RICHLAND COUNTY
BOARD OF
ZONING APPEALS

**09-04 V
Genesis Consulting Group
110 Clemson Rd. Ext.
Columbia, SC 29229
25608-01-40**

CASE 09-04 V GENESIS CONSULTING GROUP

TO: Richland County Board of Zoning Appeals; Interested parties
FROM: Carl D. Gosline, AICP, RC Transportation Planner
DATE: March 26, 2009
RE: Reconsideration of 09-04-V - Firestone Store @ Clemson & Sparkleberry Roads

01 CONCEPTUAL SITE PLAN
1" = 20'-0"

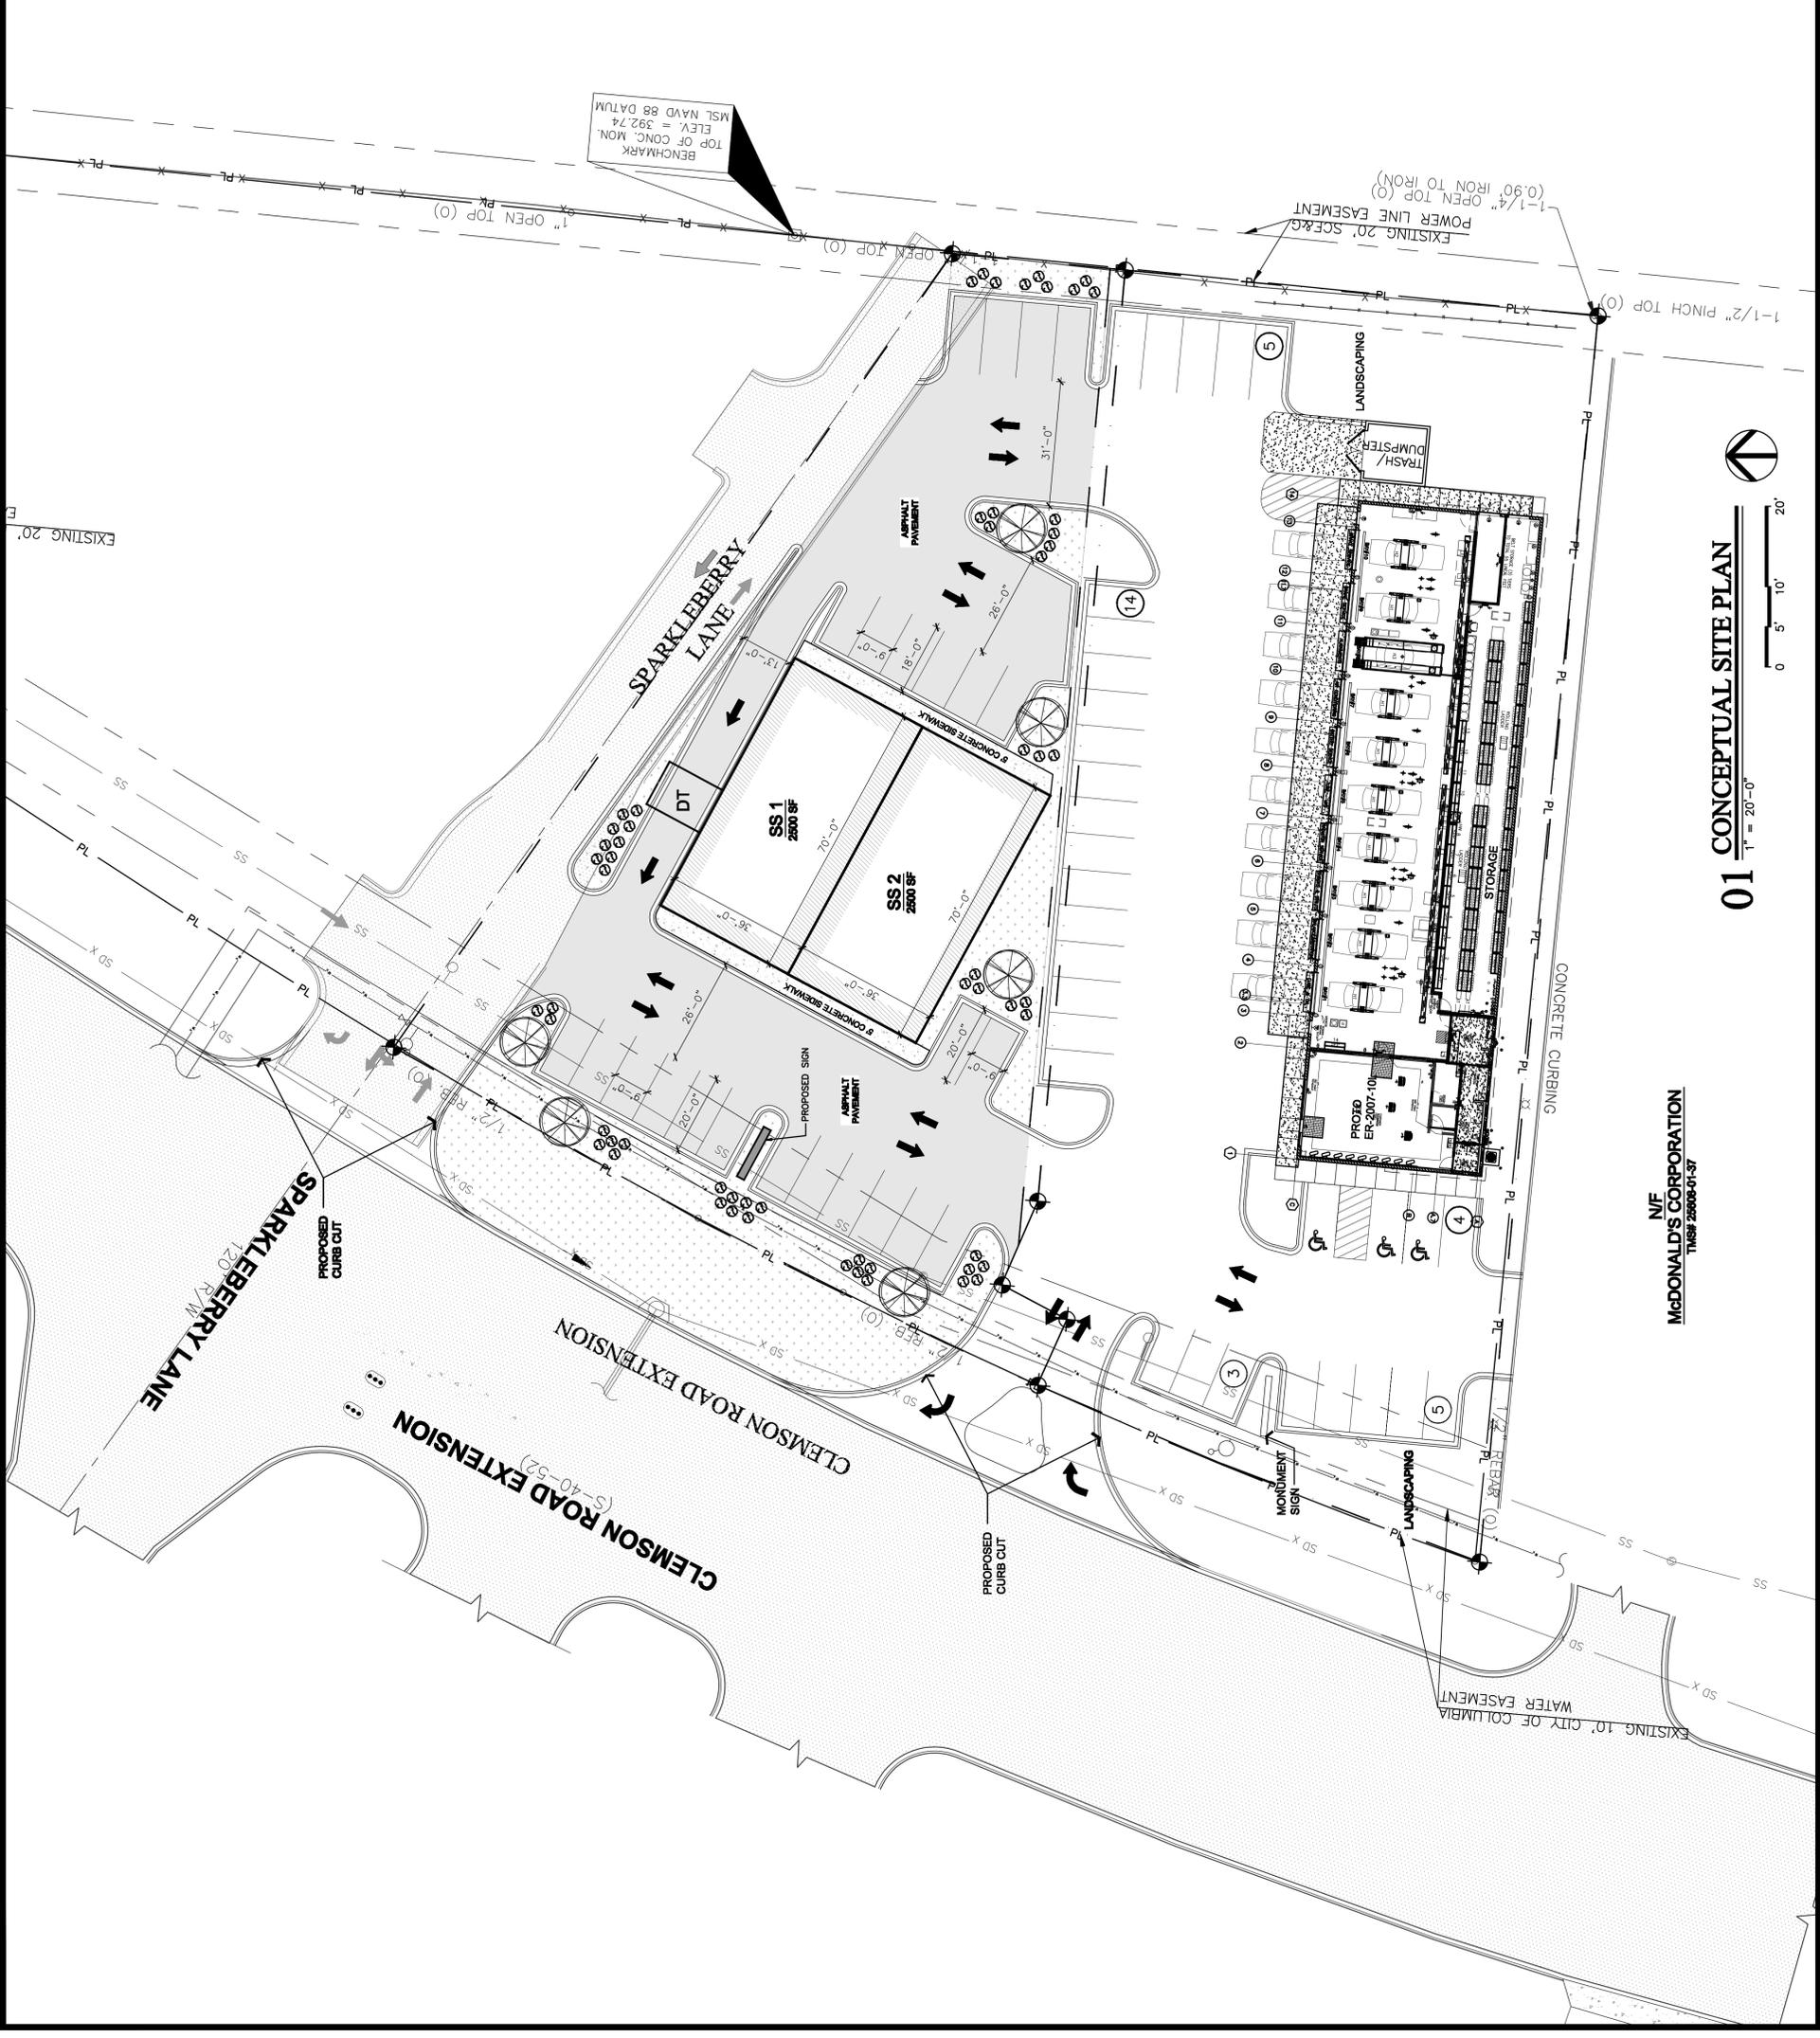
The proposed site development diagram in Tab 3 depicts the cross access easement and two entrances to Sparkleberry Lane. The diagram also identifies approximately half of the site as “future development”.

The PDSD has repeatedly advised the applicant that we will not approve a site plan, regardless of the RIRO decision, unless it identifies all types and the respective amounts of development on the whole site. We have also repeatedly advised the applicant that we

will not accept two entrances onto Sparkleberry Lane, particularly since one of the proposed driveways is only 40 feet from the Clemson Rd right-of-way.
